H12035

DESCRIPTIVE REPORT

General Locality Keku Strait

Descriptive Report to Accompany Hydrographic Survey H12035

Figure 3: Sound Speed Blowouts

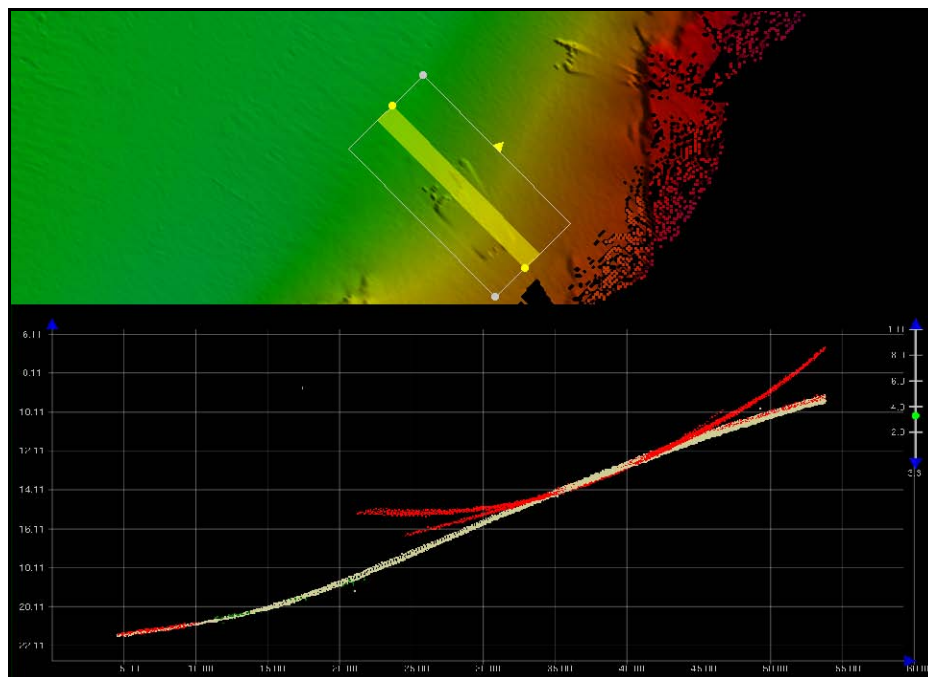
Data acquired by 1101 (RA-1) on DN 140 exhibited several significant sound velocity errors that occurred at random intervals during survey operations (Figure 3). These errors resulted from a failure of the Digibar surface velocimeter. The recurring failures were found after the Keku Strait project was concluded, and the faulty Digibar was replaced. Because this sonar uses surface sound speed input for beam forming, it was impossible to correct this data. In order to compensate, the Hydrographer has rejected soundings obviously in error.⁷

⁷ Concur. Data is within spec after cleaning.

Figure 6: *Holiday*

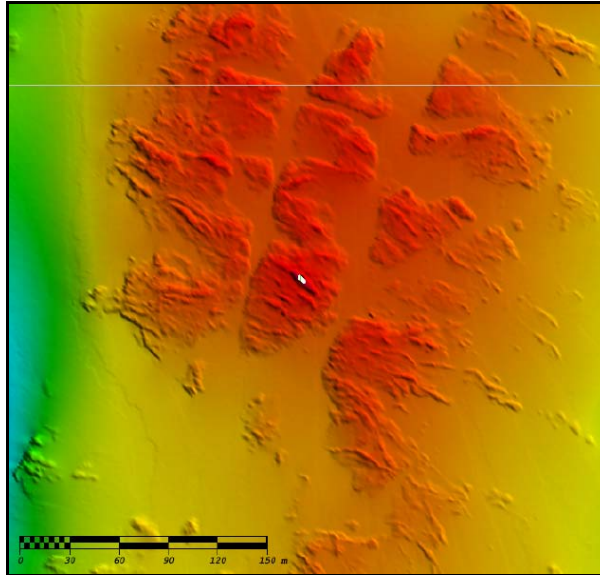
Within assigned sheet limits there is one observed holiday (Figure 6) that occurs in an area where significant shoaling indicates the likely presence of a rock. The holiday was likely caused by running “gate” filters too low on the Reson 7125 Sonar, causing the sonar to select noise over the bottom return. While conducting shoreline at a negative tide, the rock was not

visually observed. The shoalest sounding surveyed, at 3 feet, was selected and submitted as a Danger to Navigation (DTON) in report H12035_DTON1. The Hydrographer recommends charting the area as a rock awash.¹⁰

¹⁰ Concur with clarification. A rock awash surrounded by a foul area are included in the HCell.
